CJH Roof Membrane Replacement RFP Questions and Answers as of April 15, 2024

COLVILLE CONFEDERATED TRIBES
 CHIEF JOSEPH HATCHERY
**HATCHERY BUILDING
 ROOF PLAN**

HATCHERY BUILDING
 ROOF PLAN
 1/8" = 1'-0"

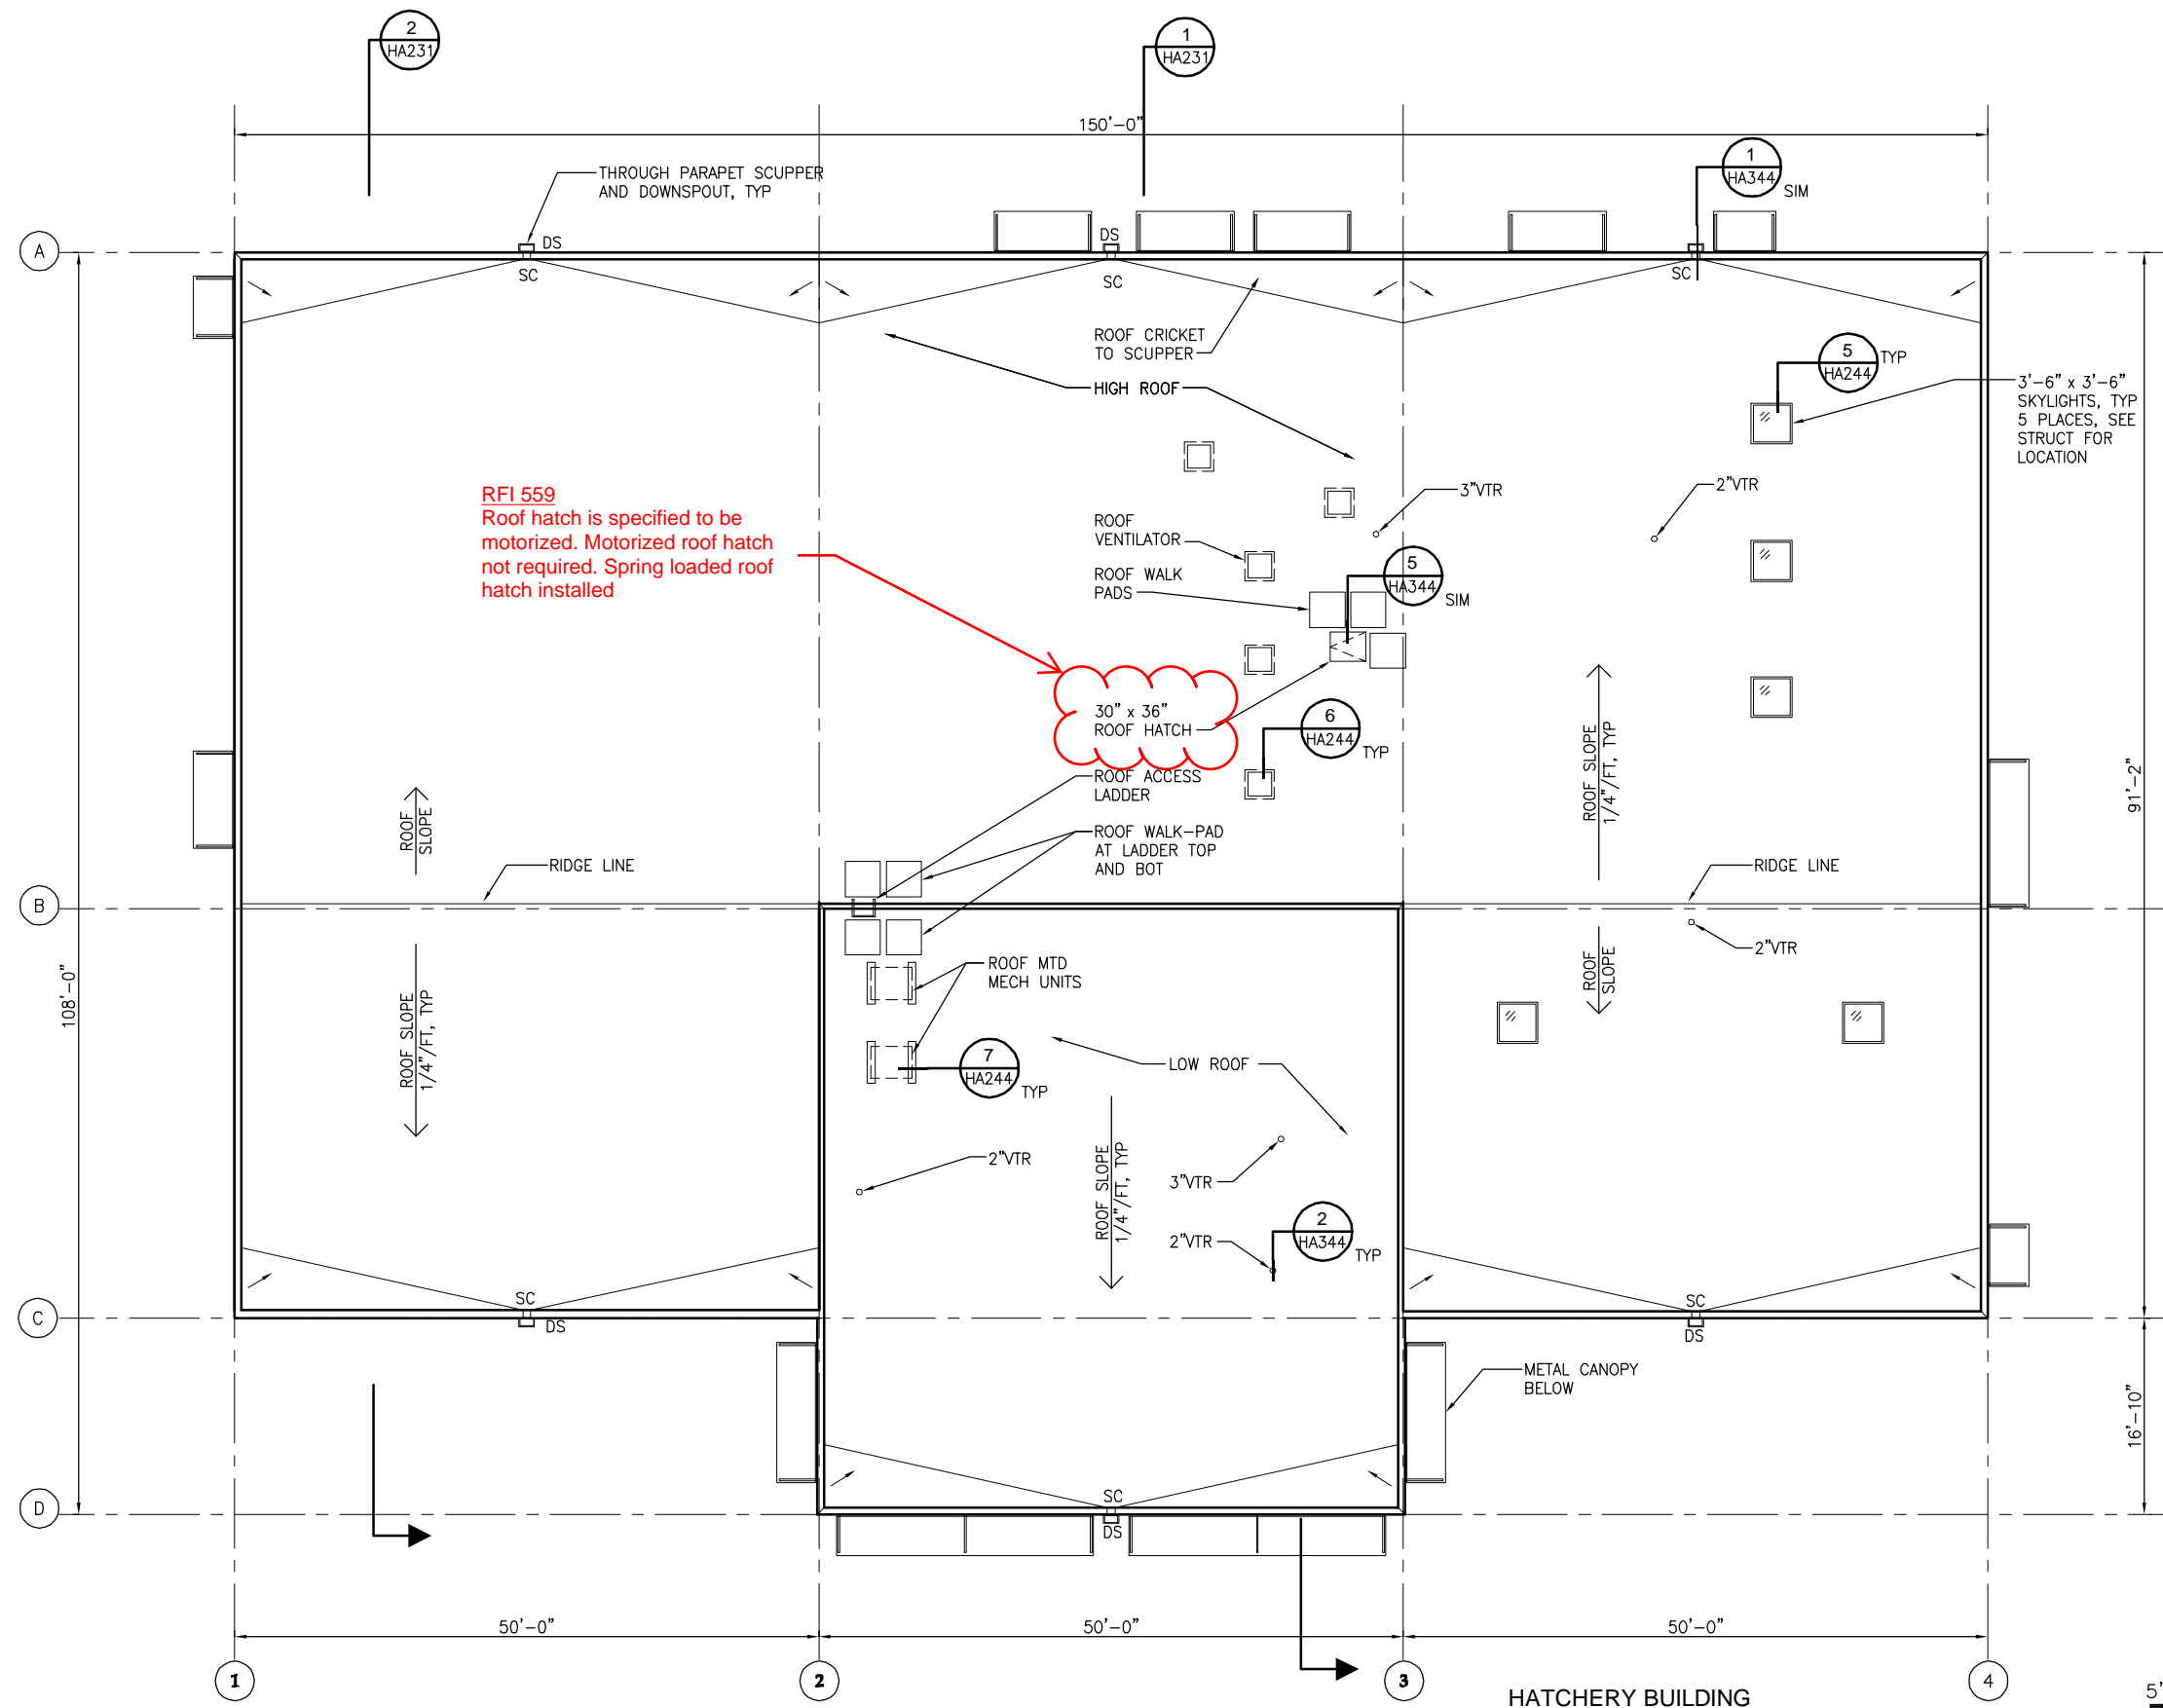
RFI 559
 Roof hatch is specified to be motorized. Motorized roof hatch not required. Spring loaded roof hatch installed

OFFICE BUILDING
 ROOF PLAN
 1/8" = 1'-0"

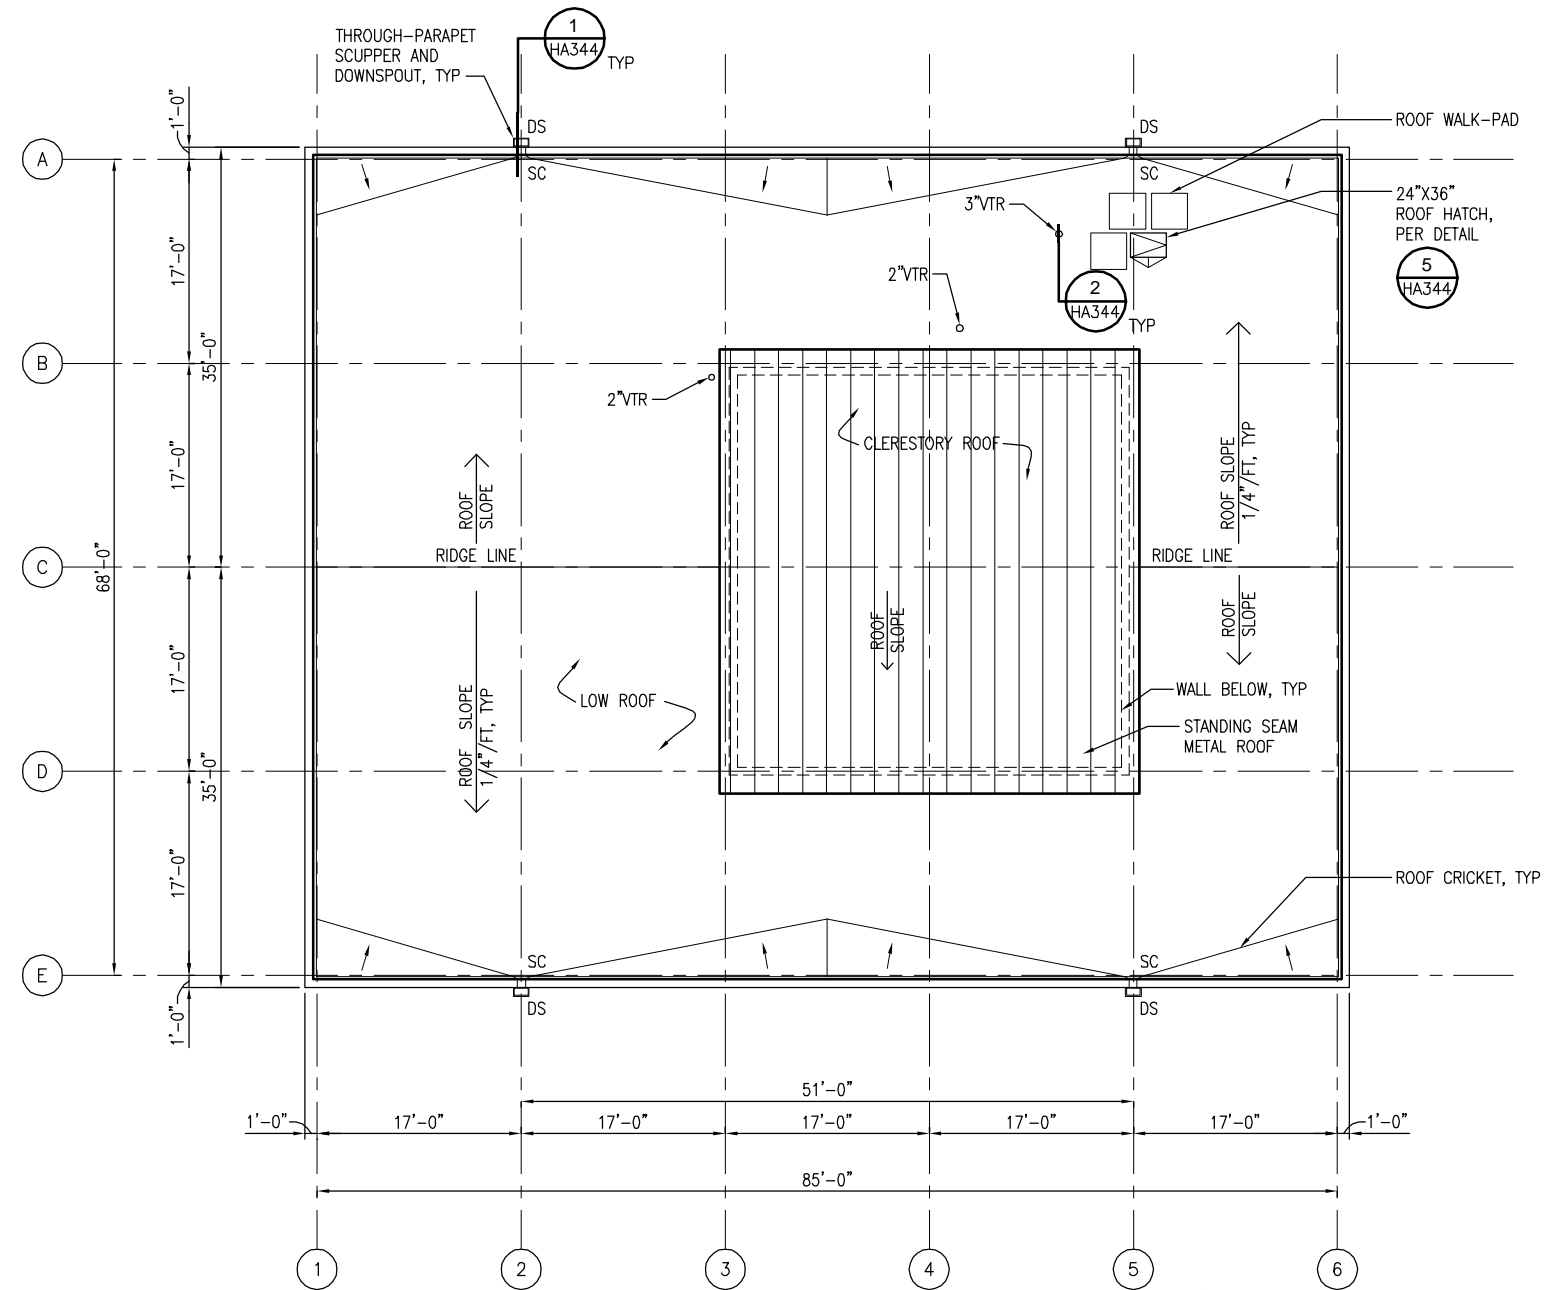
RFI 570
 Membrane roof changed to fully
 mechanically fastened roof system.
 Exposed fasteners are not acceptable
